April 11, 2019

To: Ridgeland WRF Expansion Plan Holders

Re: Addendum #1
Ridgeland WRF Expansion

denotes a change in the plans from the addenda
The first number references the addendum number while
the second number references the addendum item number

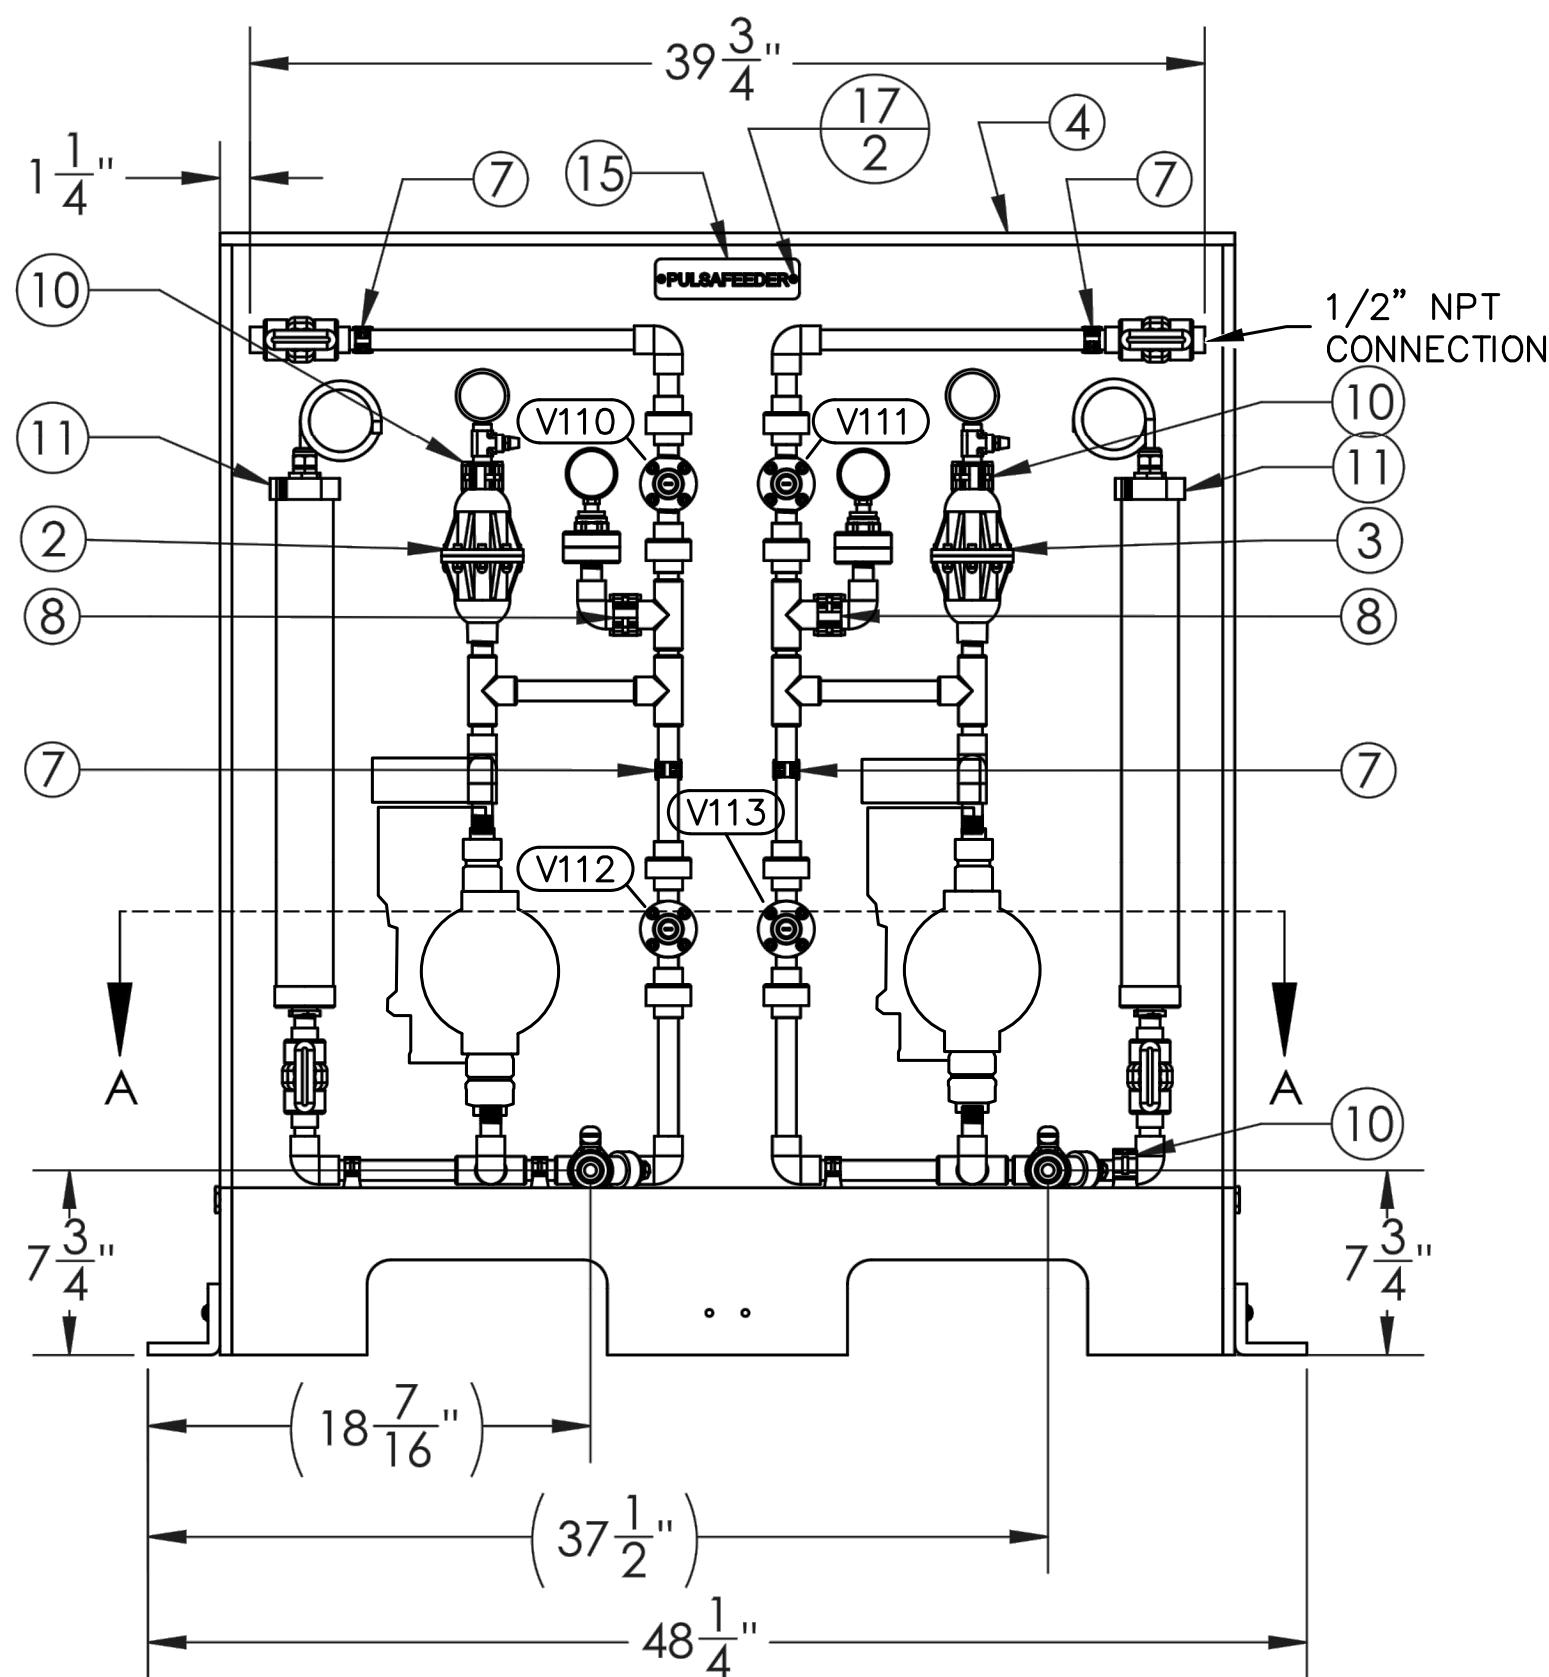
1.12	Influent pump station - M101	<ol style="list-style-type: none"> The existing pump station is 17.5' x 8' x 18.5' (Top of wetwell to bottom of wetwell). You may use a 20' x 10' x 17' box if that helps you with excavation costs.

Addendum Reference #	Reference	Question / comment
1.13	Influent pump station - M101 - ESC002, ESC003, C001, C011, C012, M111	<p>1. The valve box has been eliminated and the valves will be placed above ground.</p>

Splitter Box Plan

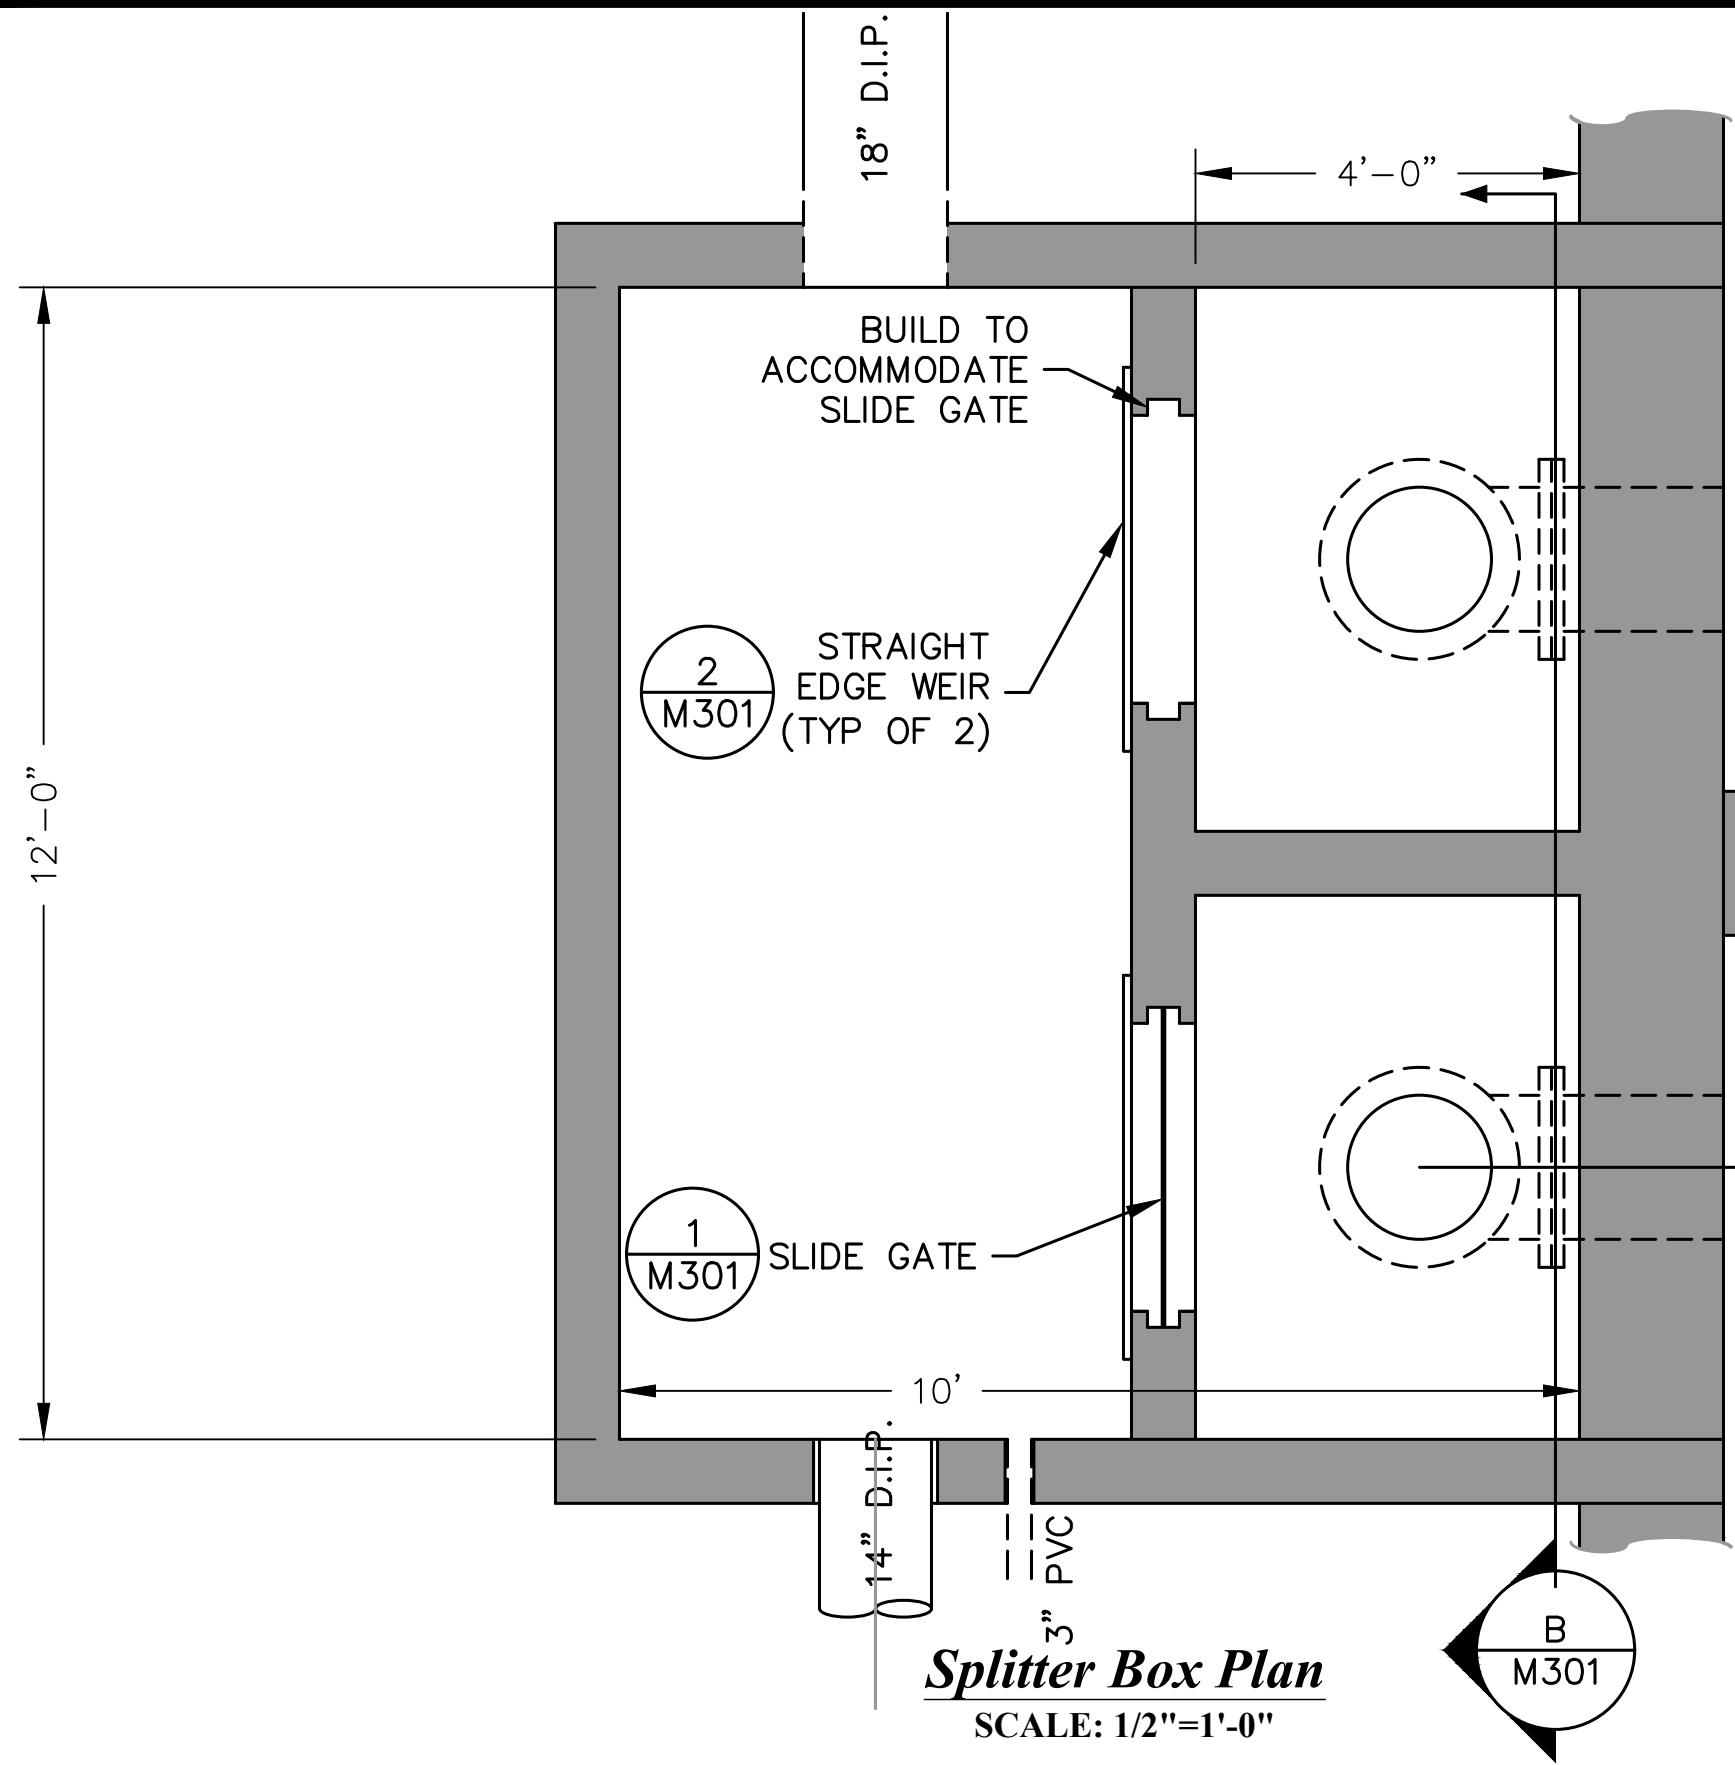
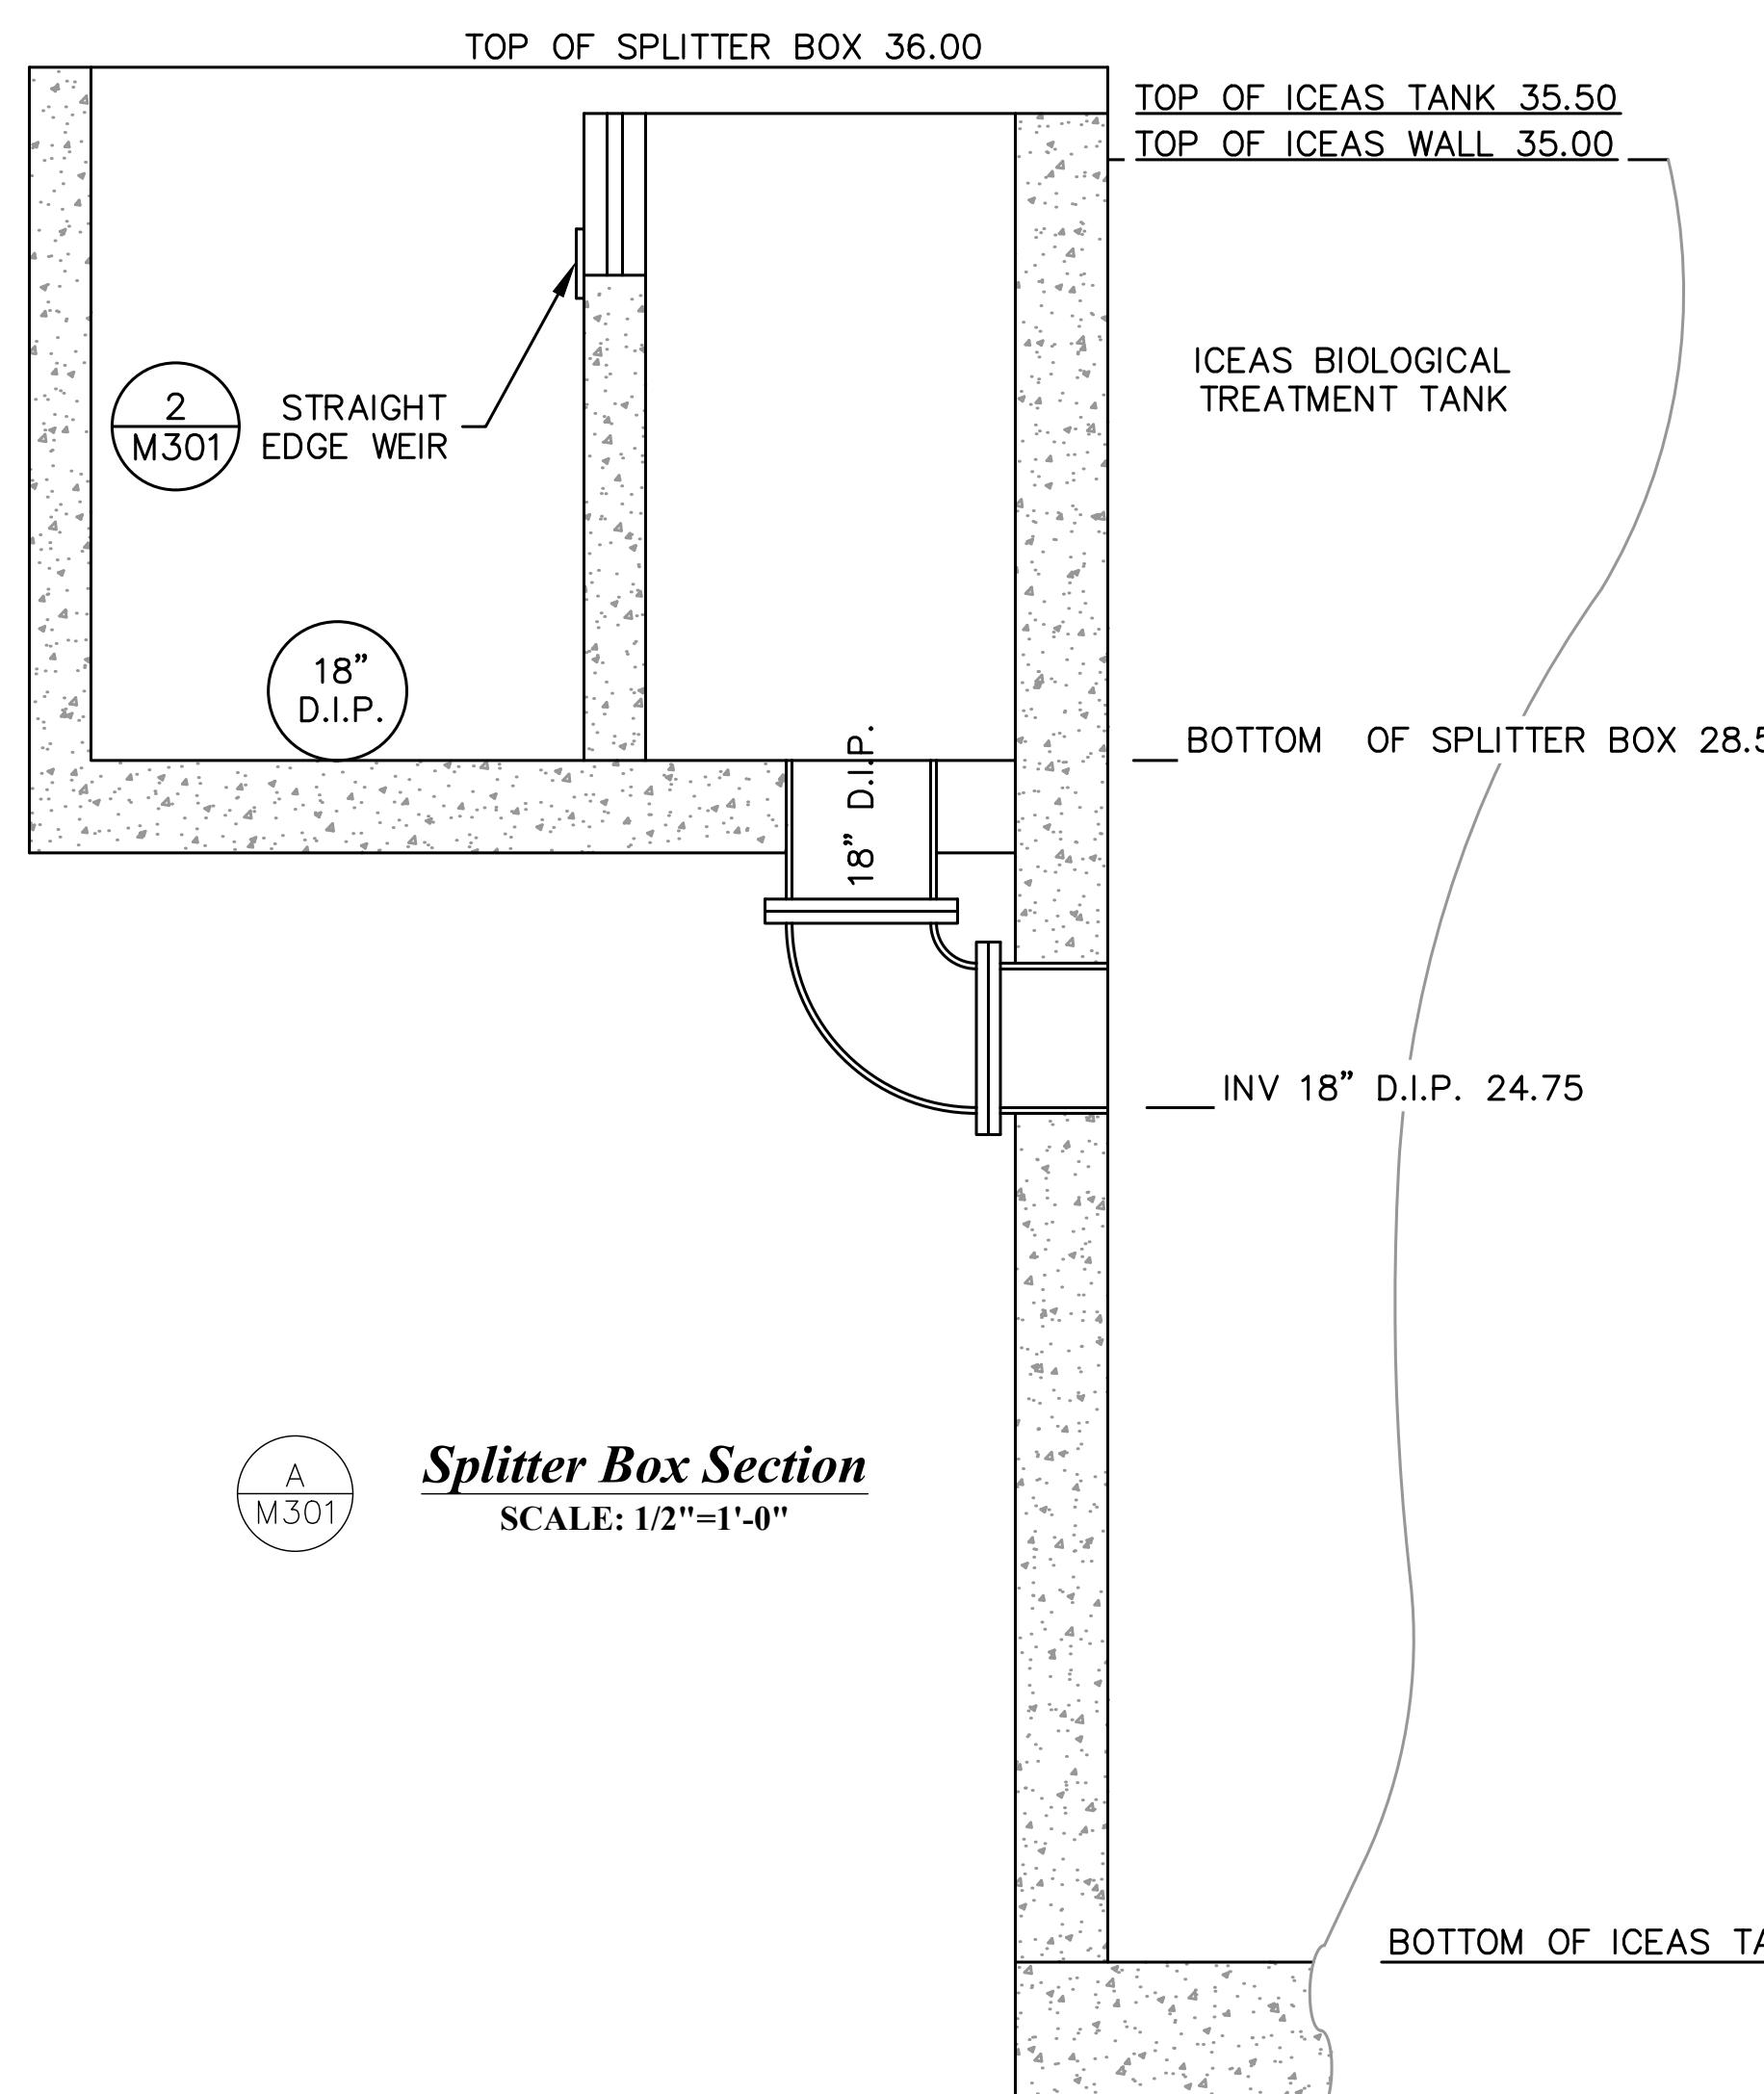
1.2 PIPE FROM HEADWORKS RELOCATED
